Re: Proposed development of Healy Corner, 195 Tahattawan Road

To the Town of Littleton Planning Board:

Figure 1 Intersection traffic pattern

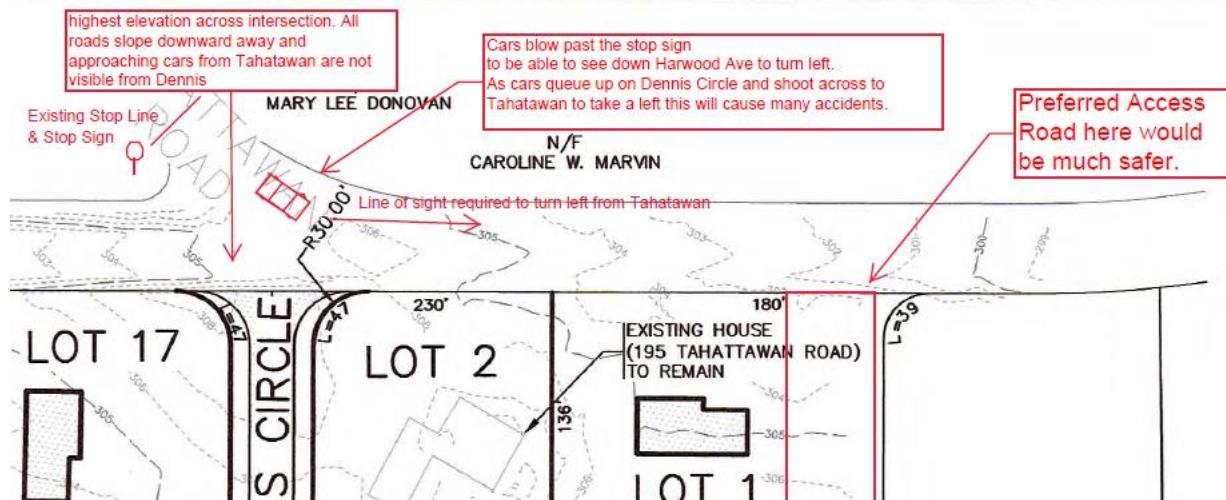
As per the current plan the Dennis Circle road will intersect with Harwood directly across from the existing skewed intersection of Tahattawan. This is already a dangerous intersection which cannot safely accept additional traffic from the development as proposed. Vehicles would enter

this intersection driving south on Tahattawan directly into new oncoming traffic from Dennis Circle, prior to having the necessary line of sight to proceed (see Figure 1.)
